SERVICE BULLETIN

This service bulletins affects all Zombie Revenge U/R games

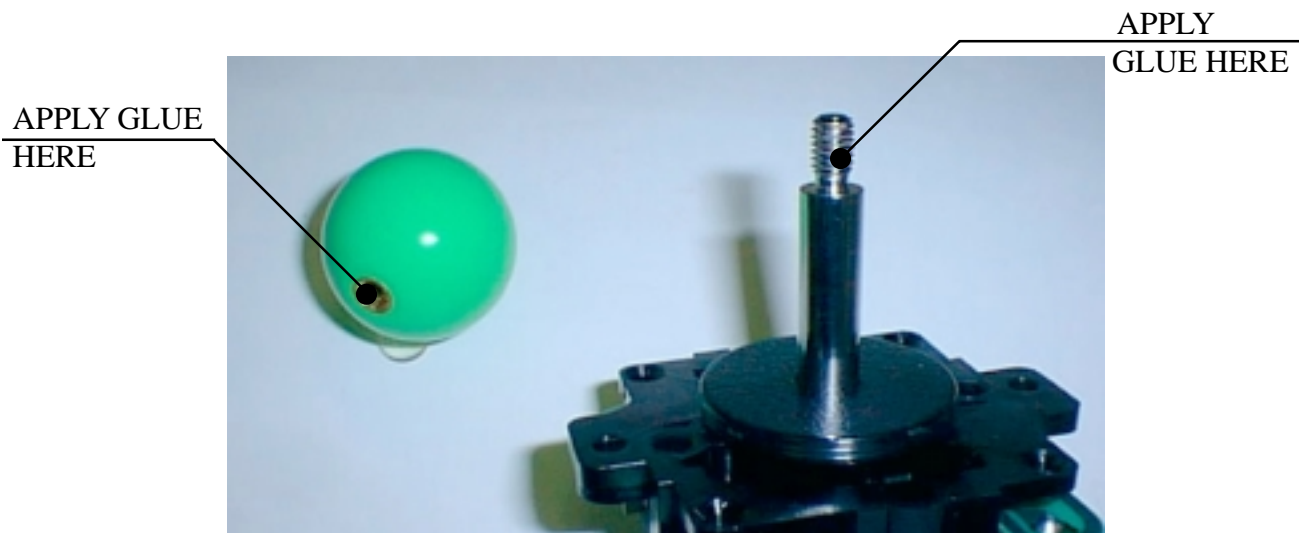
Problem: Joystick knobs work loose and are unscrewed by players during game play.

Solution: Secure the joystick knob to the shaft by using the steps below:

- 1.) Unscrew and remove the joystick knob from the shaft.
- 2.) Clean all threads.
- 3.) Apply super glue(cyanoacrylate) to the threaded hole in the knob.
- 4.) Re-apply the knob to the shaft and tighten allow 10-15 min for glue to dry.

USE GLUE SPARINGLY! (It is not necessary to apply glue to both portions)
